IW-ER-LT0346

### RE: Mitchelstown Waste Water Discharge Licence - Technical Amendment Application D0202-01

Michael Ó'Leary Acting Head of Environmental Regulation Appendix 1. Map of Stormwater Overflows Location

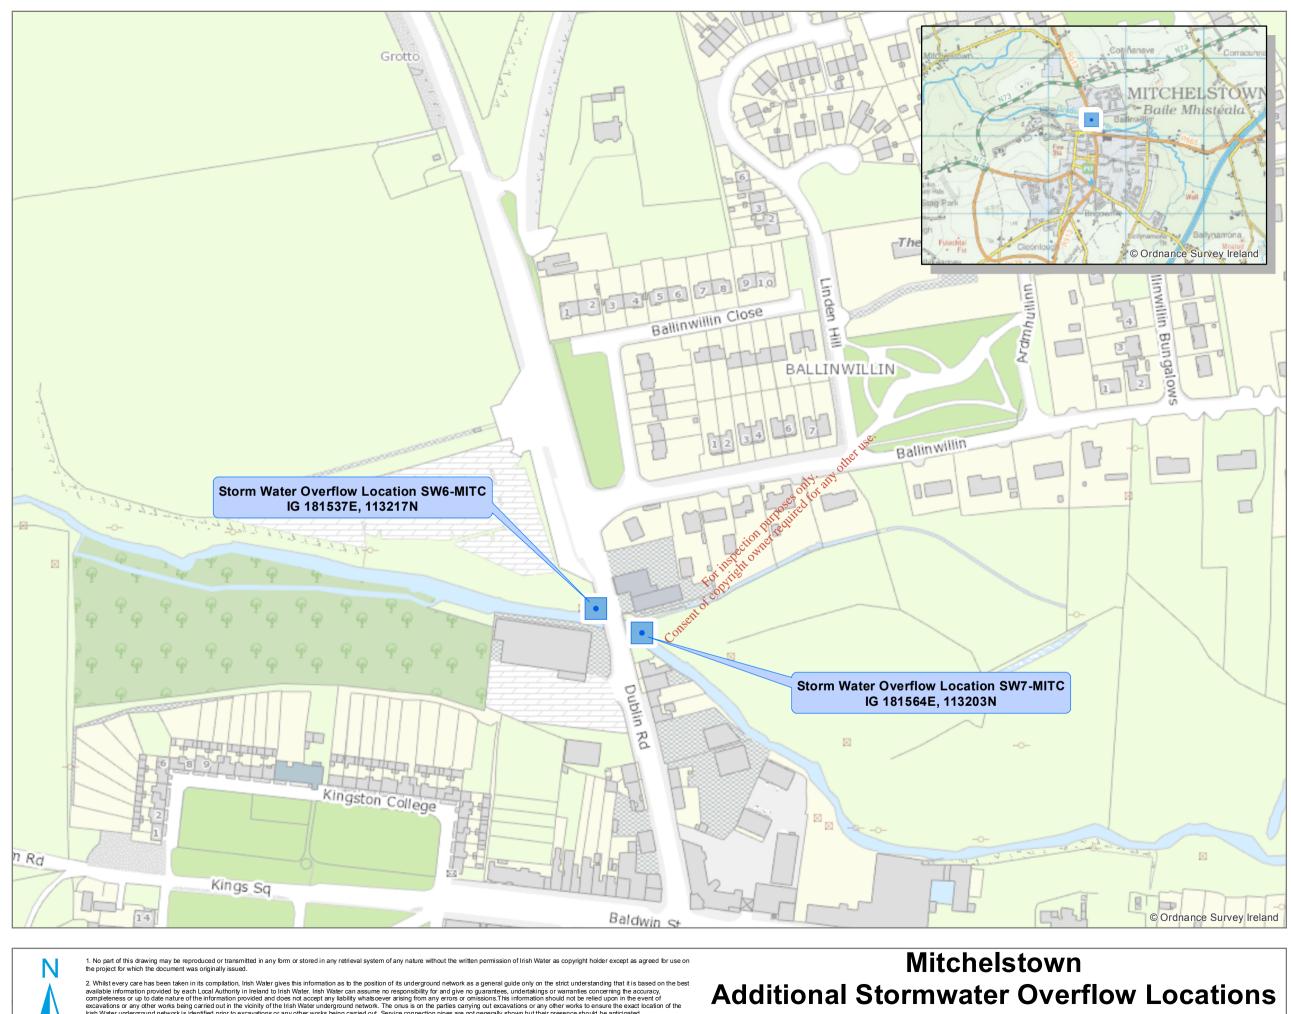
The Agency issued a Wastewater Discharge Licence for the Mitchelstown Agglomeration (D0202-01) on the 5<sup>th</sup> July 2010. Irish Water now requests a Technical Amendment under Section 33 (1) of the Waste Water Discharge (Authorisation) Regulations 2007, to amend *Schedule A.3 Storm Water Overflows*, to include 2 No. additional stormwater overflows as follows:-

Licence Code	Discharge Location	Overflow Location	Туре	Name of Receiving Water	WFD Code Receiving Water
SW6-MITC	E 181537 N 113217	Bank Place / Dublin Hill, Mitchelstown	Storm Water Overflow	River Gradogue	IE_SW_18G130200
SW7- MITC	E 181564 N 113203	Ballinwillin, Mitchelstown	Storm Water Overflow	River Gradogue	IE_SW_18G130200
